Product Change Notification - SYST-24ERCX843

Data Sheet - AT24CS64 - Complete Datasheet Document Revision

SYST-24ERCX843

AT24CS64: Package Marking Information

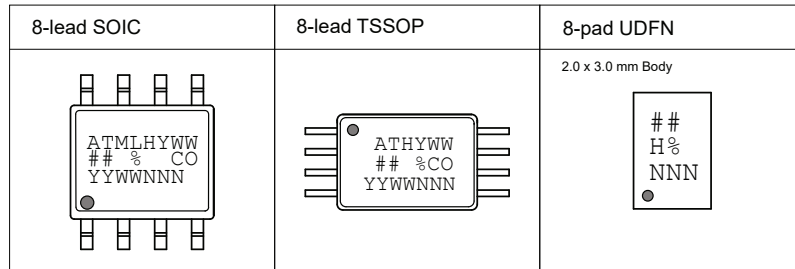
Description of Change: 1) Updated to Microchip template. Microchip DS20006296 replaces Atmel document 8870. 2) Corrected tLOW typo from 400ns to 500ns. 3) Corrected tAA typo from 550ns to 450ns. 4) Updated Package Marking Information. 5) Updated Product ID System. 6) Updated the Software Reset section. 7) Added ESD rating. 8) Removed lead finish designation. 9) Updated trace code format in package markings. 10) Updated formatting throughout for clarification. 11) Added a figure for System Configuration Using 2Wire Serial EEPROMs. 12) Added POR recommendations section.
